**V2500-A1/A5 SERIES PROPULSION SYSTEMS SERVICE BULLETIN**

This document transmits Revision 1 to Service Bulletin EV2500-79-0069

**V2500-ENG-79-0069**

OIL - PRESSURE OIL TUBES - ENGINE - INTRODUCTION OF RE-ROUTED OIL TUBES AND REVISED  
CLIPPING ABOVE THE EXTERNAL GEARBOX

Schematic view of pressure oil tubes - Before and after alteration  
Fig 1

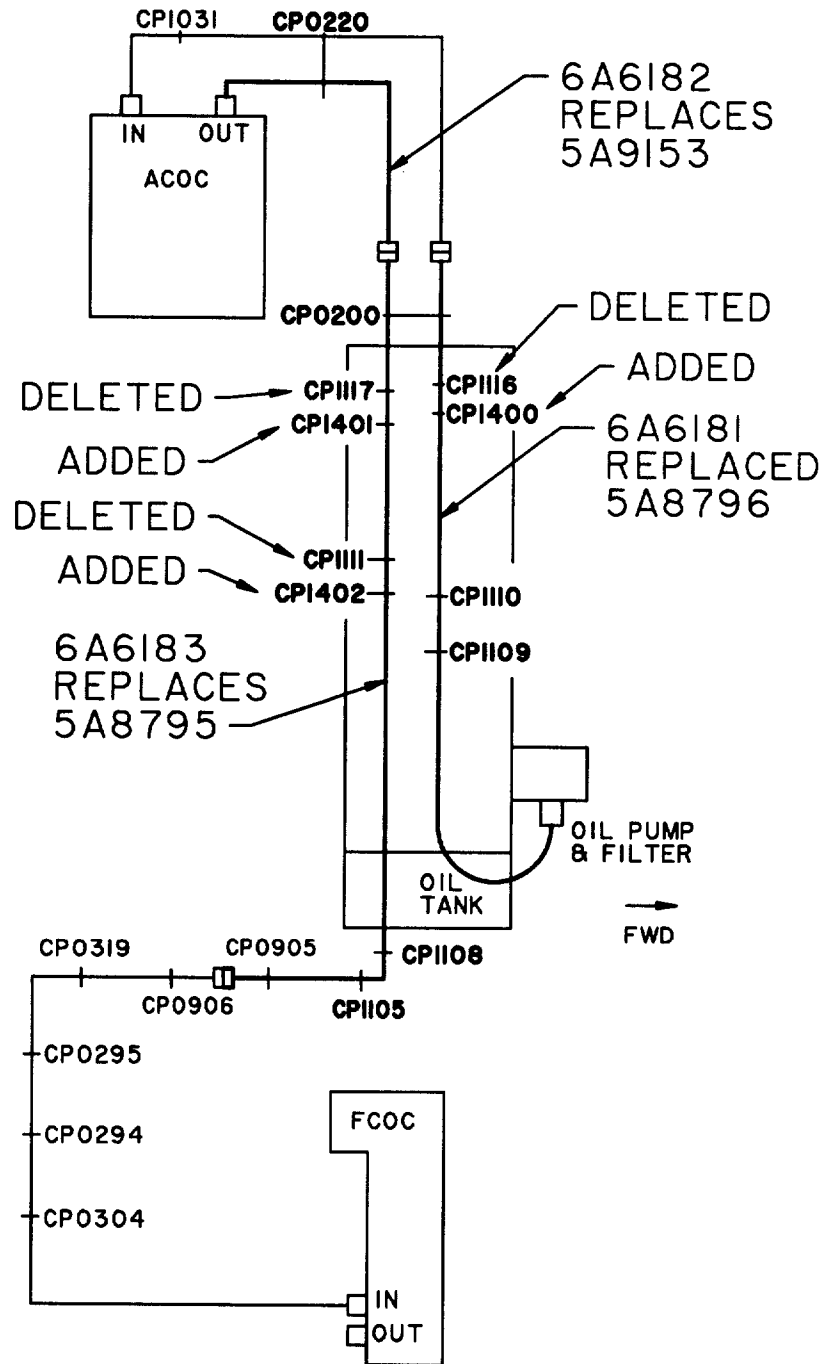
(1) The ACOC and FCOC tubes have been revised, the changes are as follows:

(a) The tube assemblies that follow are re-routed to give additional clearance with the cast mounting boss of the external gearbox:

- (2) Remove tube assembly 5A9153. (Refer to Figure 1).
  - (a) Disconnect the tube at the ACOC outlet port and the connection with tube 5A8795.
  - (b) Disconnect the tube from clip point CP0220.

- (i) Remove and discard the tube.
- (3) Remove tube assembly 5A8795. (Refer to Figures 1, 2 and 3).
  - (a) Disconnect the tube from CP0200, CP1117, CP1111, CP1108, CP1105 and CP0905.

- (c) Remove and discard brackets 5W8399 and 4B7265.
- (4) Remove tube assembly 5A8796. (Refer to Figures 1 and 2).
  - (a) Disconnect the tube from CP0200, CP1116, CP1110 and CP1109.

- (i) Remove and discard the tube.
- (5) Install tube assembly 6A6183. (Refer to Figures 1, 2 and 3).
  - (a) Install the brackets 6A7437 and 4B7340 for CP1401 and 1402.

- (c) Connect the tube to the disconnect point adjacent to CP0906 torque the connector to 478 to 513 lbfin (54 to 58 Nm).
  - (d) Attach the tube to CP0905, CP1105, CP1108, CP1402, CP1401 and CP0200 and torque the nuts to 36 to 45 lbfin (4 to 5 Nm).

- (6) Install tube assembly 6A6182. (Refer to Figure 1).
- (a) Connect the tube to the disconnect point adjacent to CP0200 and the outlet port of the ACOC. torque the connectors to 478 to 513 lbfin (54 to 58 Nm).

- (b) Attach the tube to CP0220 and torque the nut to 36 to 45 lbfin (4 to 5 Nm).
- (7) Install tube assembly 6A6181. (Refer to Figures 1 and 2).
- (a) Install bracket 6A7437 for CP1400.

Clipping point 1400 and 1401

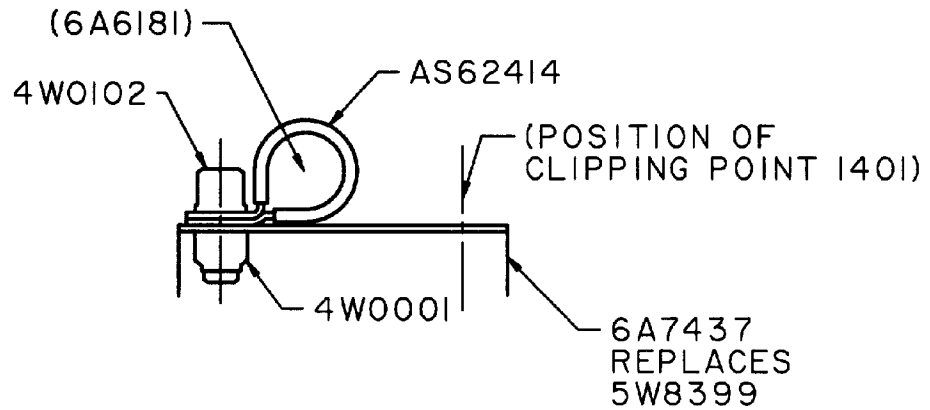
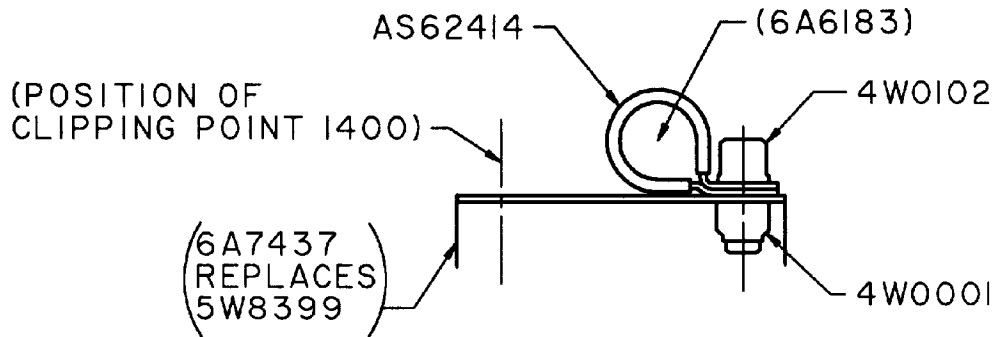
- (b) Install CP1400.
  - (c) Connect the tube to the disconnect point adjacent to CP0200 and the oil pump and filter assembly torque the connectors to 478 to 513 lbfin (54 to 58 Nm).

- (d) Attach the tube to CP1109, CP1110 and CP1400 and torque the nuts to 36 to 45 lbfin (4 to 5 Nm).
- (8) Install the External Gearbox Module (Refer to the V2500 Engine Manual (E-V2500-1IA), Chapter/Section 72-00-60, Installation-01 or Installation-02).

Clipping point 1402  
Fig 3

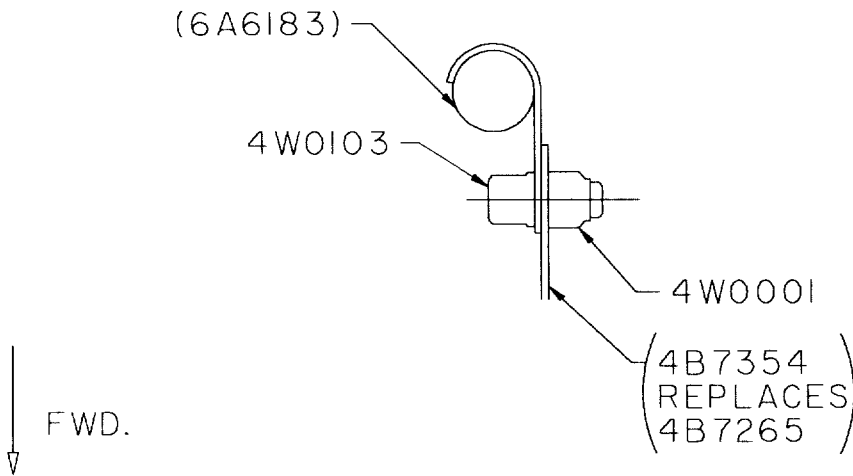
- (b) Install CP1401 and CP1402.
